RECORD PLANS

PROPOSED IMPROVEMENT
 BRIDGE PROJECT

PROJECT NAME: MENDON
PROJECT NUMBER: BRO 1443(43)

51+80

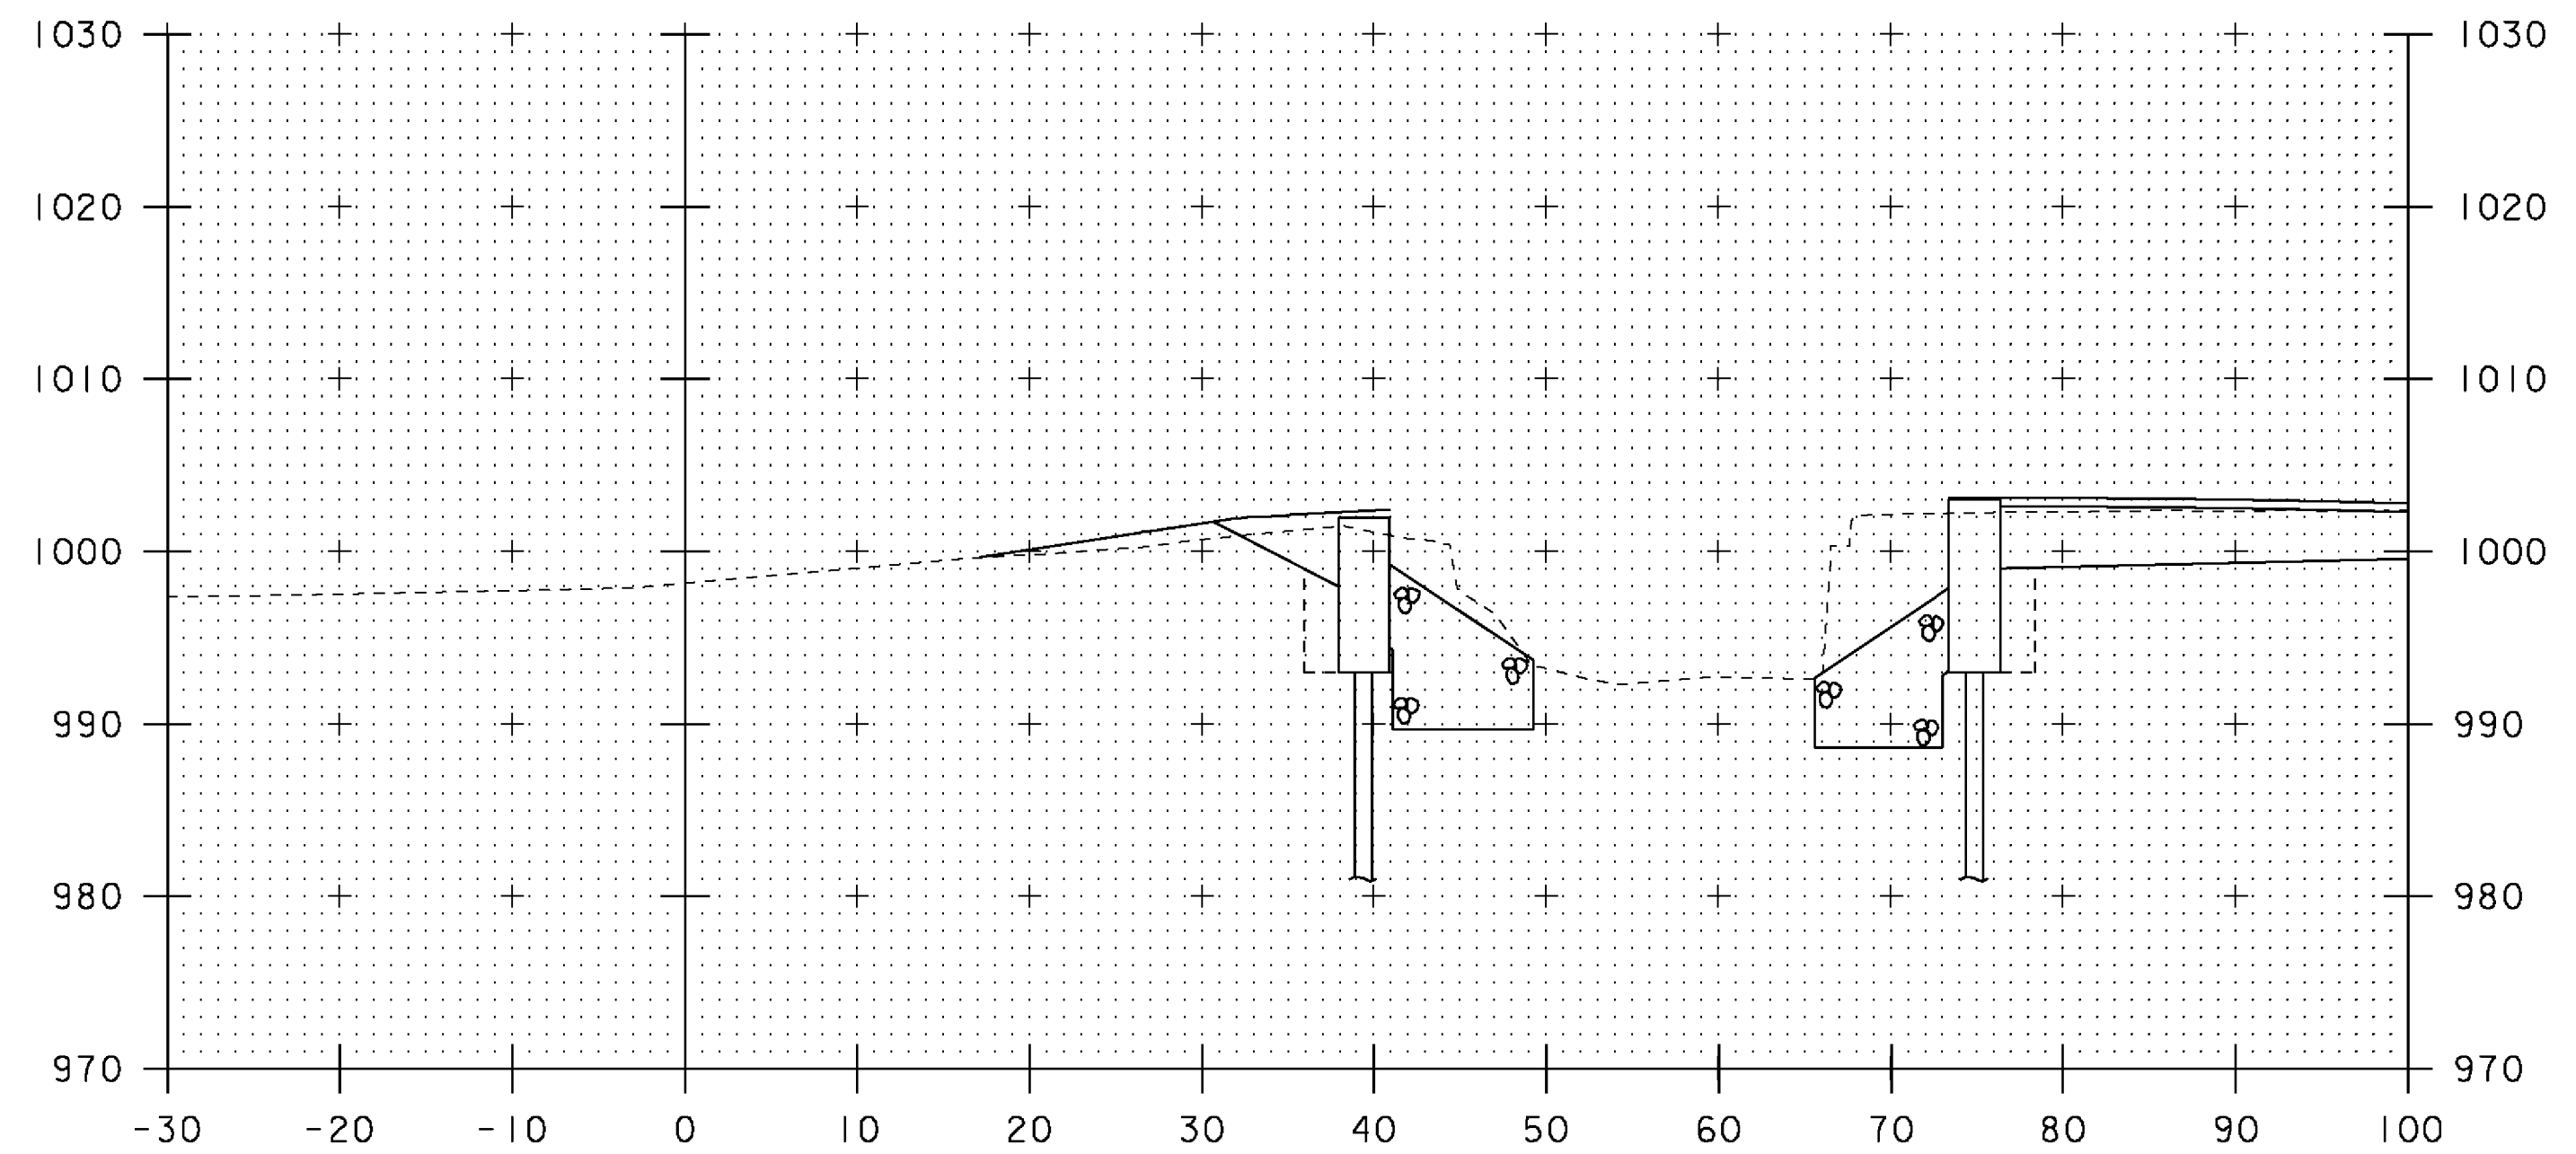
EXISTING GROUND NO LONGER VALID SINCE IRENE 8-28-II.
 NEW SURVEY REQUIRED FOR CHANNEL SECTIONS
 (TYP ALL SHEETS 31 & 32).
